SERVICE BULLETIN

RM 7211/71/75/91/95, RM 7361/65/71/91/95, RM 7401/05, RM 7501/41/45/51/55, RM 7601/05/51/55, RM 7801/05/51/55

Additional Ground connection for MES and AES III

Connection cable, 241 2796-03/5

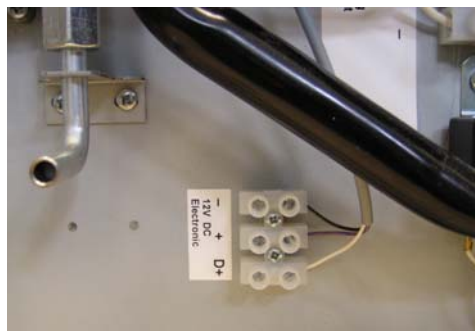
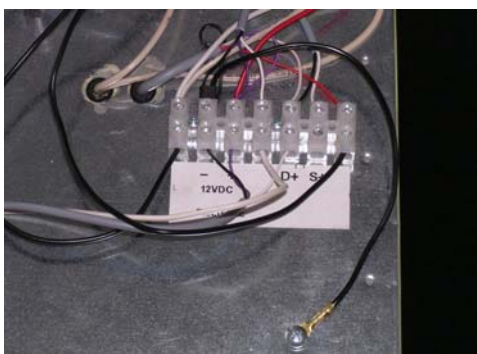
An inadequate ground connection in the leisure vehicle can cause a high current flow via the electronics (contact X105) of the fridge to the grounding at the gas line.

To avoid this and in order to protect the electronics, we created new connection cables with an additional grounding to the housing.

This cables have to be changed in case of repair, due to above mentioned error.

Fix additional grounding onto fridge housing with a screw.
